AGENDA ITEM EXECUTIVE SUMMARY

Title: Recommendation to Award the Bids for Bid Package #3A, Bid Package #2 Scope Changes and Unsuitable Soil Remediation Costs for the Police Station Project

RE: Request for Authorization to Proceed
71810-500: St. Charles - New Police Facility

Change Order Type	Change Order No	Description
Potential Change Order	PCO-004	Foundation Undercuts

Test Pit Location Diagram

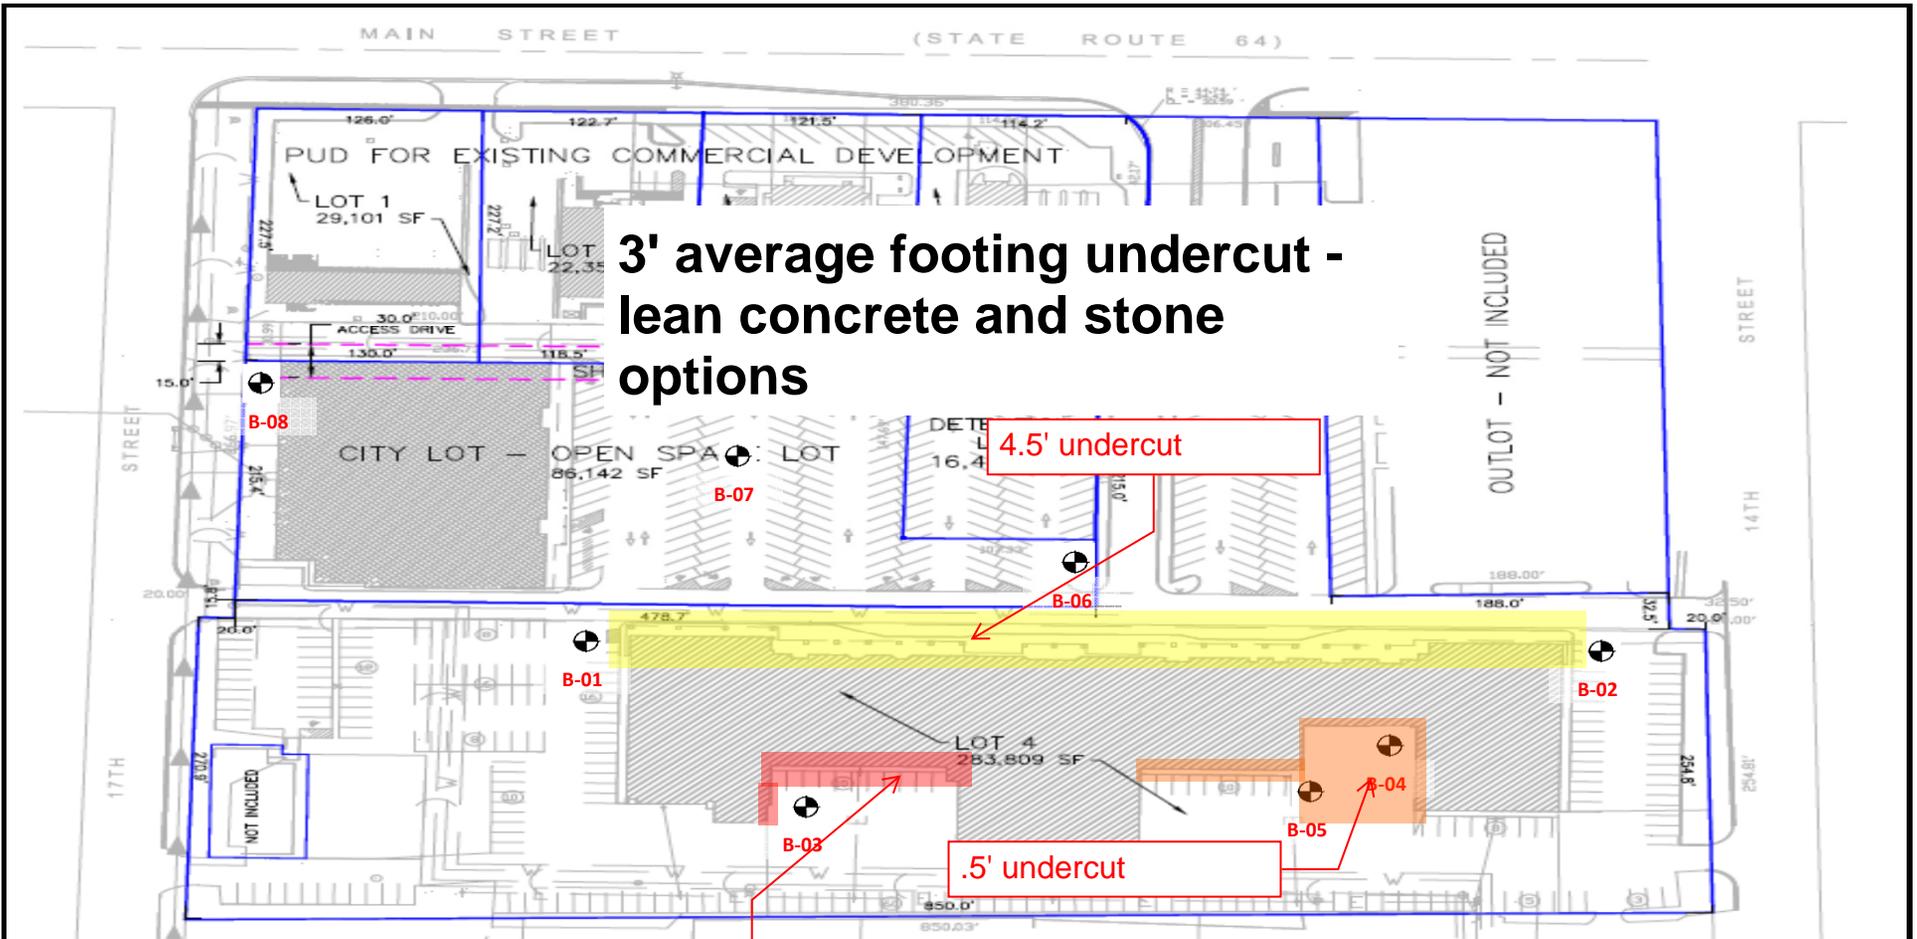
Due to the nonstructural soils found at the building pad proposed location, the construction testing agency has recommended undercutting the foundation where needed. The depths range in depth but for purposes of an estimate, we have averaged the entire building perimeter at a three (3) floor undercut depth totaling the amount shown below. This is not a guaranteed total, but simply an estimate based on the existing conditions.

3' average footing undercut - lean concrete and stone options

4.5' undercut

2.5' undercut

.5' undercut

PCO Item	Item Notes	Days +/-	Price
1 : Undercut options based on T&M pricing.	Remove & Replace Unsuitable Soils w/ 3" Stone \$70.00/CY Remove & Replace Unsuitable Soils w/ CA6 Stone \$65.00/CY		T&M with estimated value of \$25,000.00
